Transport Access Program **Canley Vale Station Upgrade** Determination Report

Canley Vale Station Upgrade – Determination Report

Ref – 6458341

Figure 3 Revised key features of the Proposed Activity (indicative only, subject to detailed design)

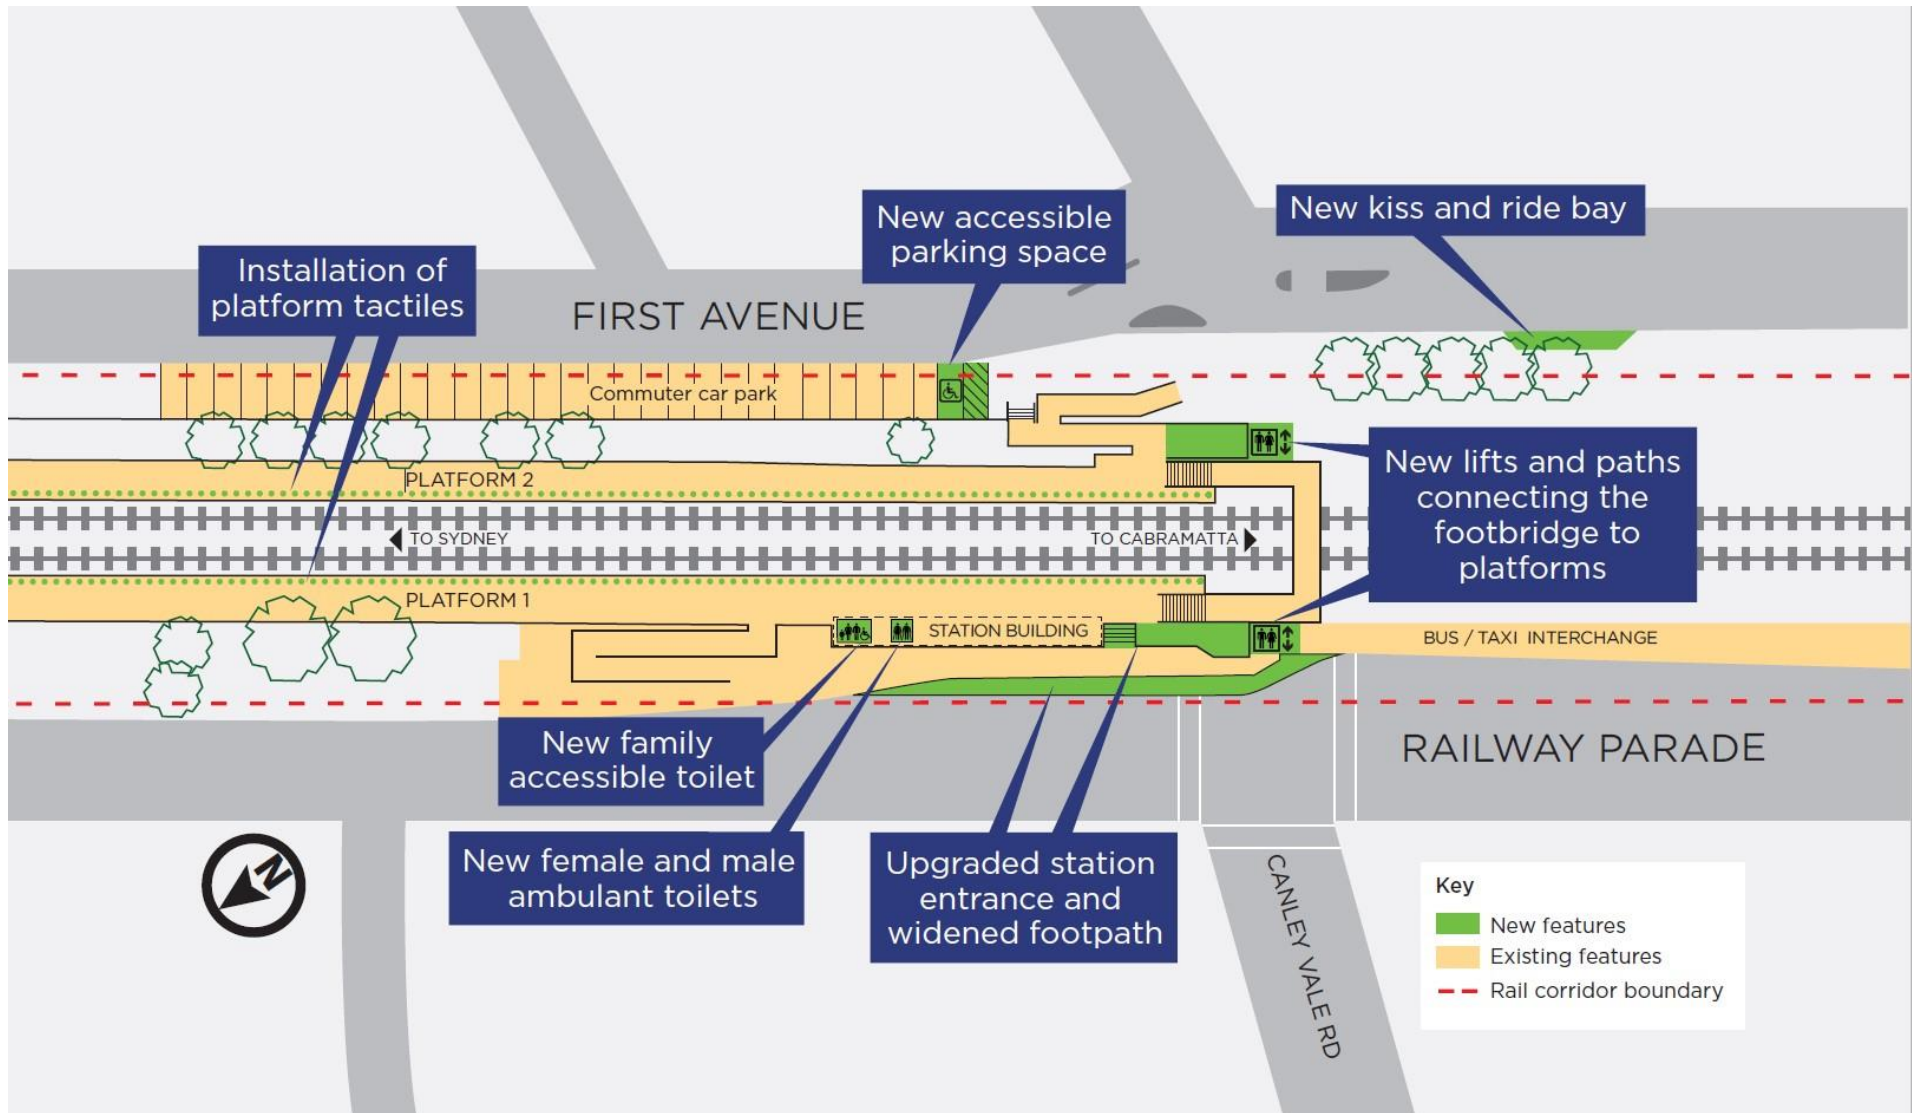
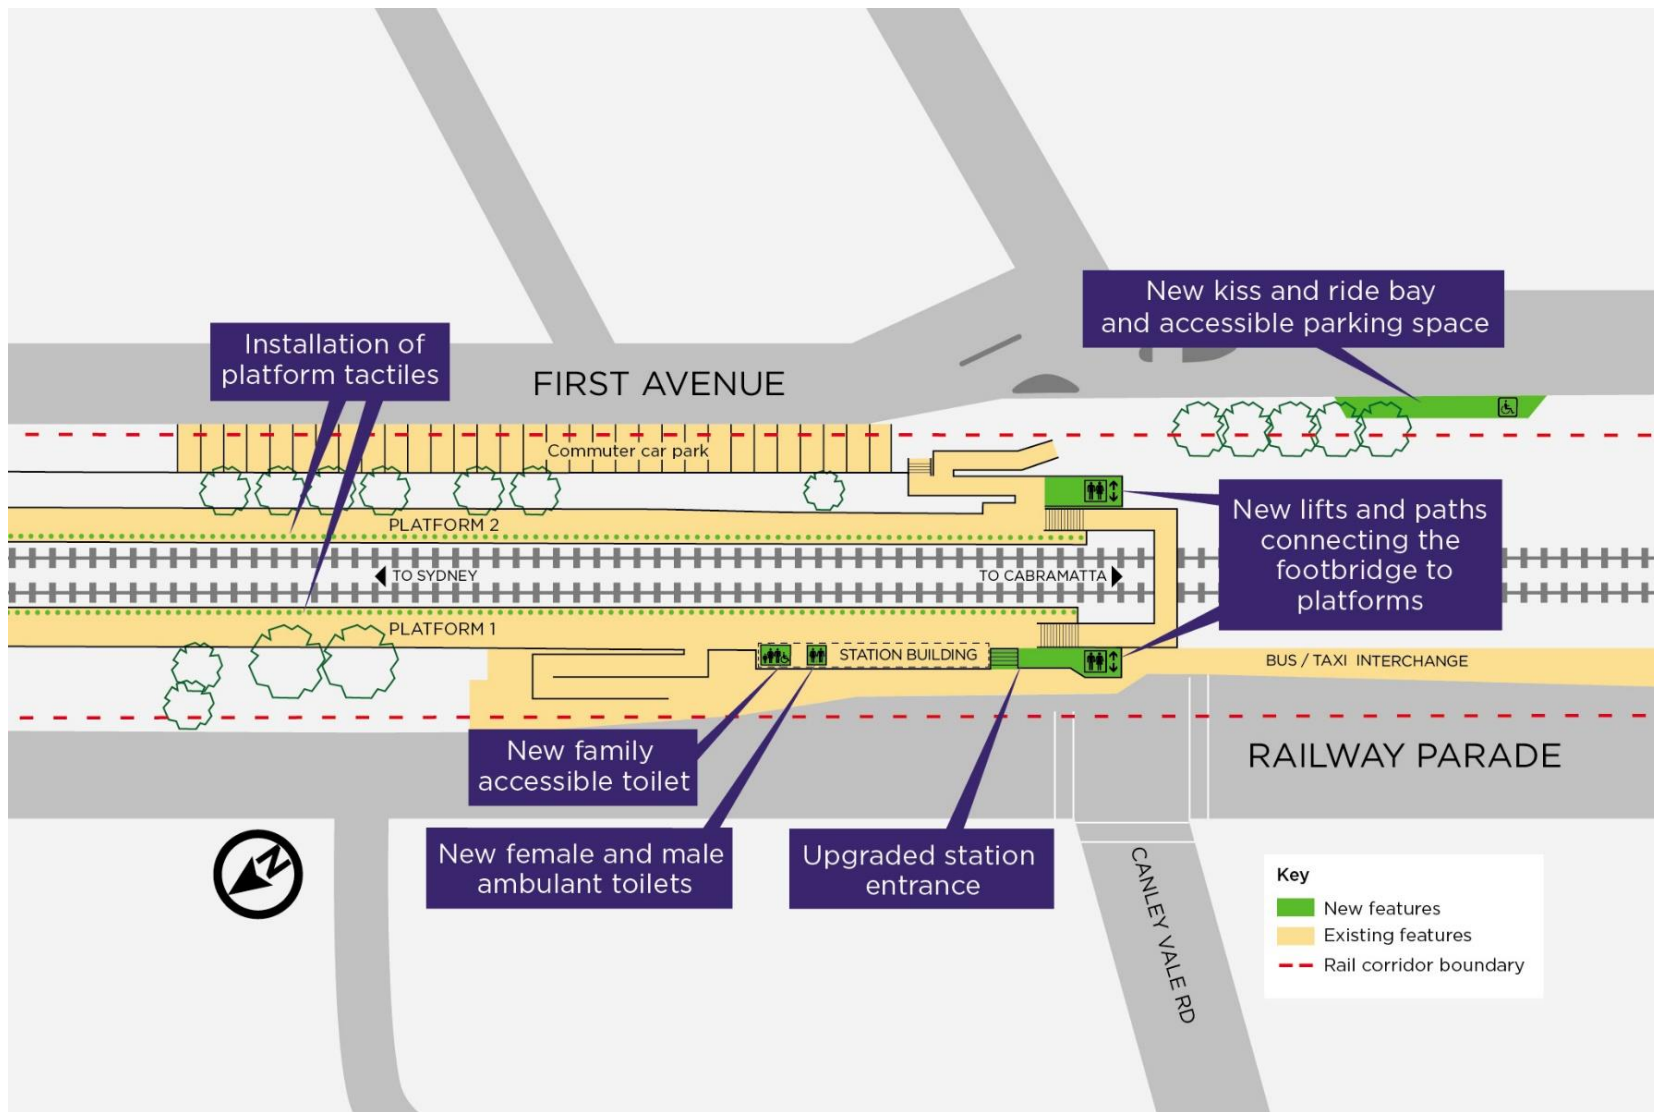
Aspect of the Proposed Activity	Design change	Discussion of impacts
Lift to Platform 1	The location of Lift 1 has been moved about one to two metres north in the direction of the Station Building.	The proposed new lift location would not introduce additional environmental impacts to what has been assessed in the REF. The visual impacts of the new lift location are considered to be consistent with those identified in the <i>Landscape Character and Visual Impact Assessment</i> (Envisage, 2020). The design change would create more space between the lift and the footpath kerb on Railway Parade.
Lift to Platform 2	The location of Lift 2 has been moved about one to two metres north in line with Lift 1.	The proposed new lift location would not introduce additional environmental impacts to what has been assessed in the REF. The visual impacts of the new lift location are considered to be consistent with those identified in the <i>Landscape Character and Visual Impact Assessment</i> (Envisage, 2020). The design change to the location of Lift 2 is required to reduce extensive service relocations.

Railway Parade footpath	The footpath would not be widened as initially proposed in the REF.	The footpath would no longer need to be widened as the new location for Lift 1 would ensure pedestrian passing widths on the existing footpath are maintained.
First Avenue Carpark and the proposed kiss and ride	The new accessible parking space to be provided within the First Avenue commuter car park would now be provided next to the kiss and ride bay on First Avenue.	It has been identified that the original location within the First Avenue car park would not provide sufficient space on the road side to achieve a compliant accessible car space. This is due to the hazardous location of an open dish drain adjacent to the existing car space and the close proximity of First Avenue roadway

Aspect of the Proposed Activity	Design change	Discussion of impacts
		which the required space would encroach into. Moving the proposed accessible car space next to the kiss and ride results in no car park spaces lost within the commuter car park.

The key features of the Revised Proposed Activity are shown in Figure 3.
